**CERTIFICATE OF APPROPRIATENESS****Application Date:** May 27, 2015**Applicant:** Sam Gianukos, Creole Design, LLC for Adrian Guerra-Paz, owner**Property:** 620 Columbia Street, Lot 17, Block 281, Houston Heights Subdivision. The property includes a historic 1,279 square foot, one-story wood frame single-family residence and rear detached garage situated on a 6,600 square foot (50' x 132') interior lot.**Significance:** Contributing Queen Anne residence, constructed circa 1910, located in the Houston Heights Historic District South.**Proposal:** Alteration – Addition

**NORTH SIDE ELEVATION**

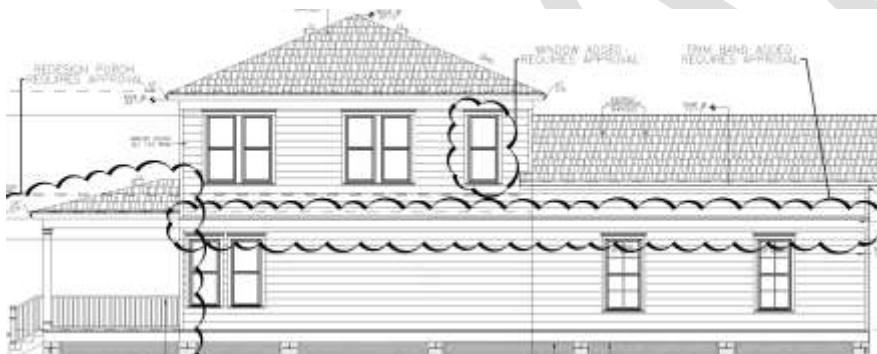
- Install a 1x12 band board under the eave on the north, and south elevations of the existing residence.
- Install a 1-over-1 sash window on the first floor of the addition on the north elevation.
- Change the three proposed divided lite entry doors on the rear elevation of the proposed addition to a single lite entry door and two single lite fixed doors.

| <input type="checkbox"/>            | <input checked="" type="checkbox"/> | <input type="checkbox"/> | (1) The proposed activity must retain and preserve the historical character of the property;<br><i>The installation of the 1x12 band board introduce an architectural element that was never present on the residence alters the character of the 1910 Queen Anne style residence.</i>  |
| <input type="checkbox"/>            | <input checked="" type="checkbox"/> | <input type="checkbox"/> | (9) The proposed design for any exterior alterations or addition must not destroy significant historical, architectural or cultural material and must be compatible with the size, scale, material and character of the property and the area in which it is located;<br><i>The installation of the 1x12 band board on the existing residence introduce an architectural element that was never present and is not compatible with the character of the contributing 1910 Queen Anne residence.</i> |

- Approval of the installation of the 1-over-1 sash window on the north elevation of the proposed addition and the installation of a single lite entry door and two single lite fixed doors on the rear elevation of the addition.
- Denial of the installation of a 1x12 cementitious band board under the eave on the north and south elevations of the existing residence
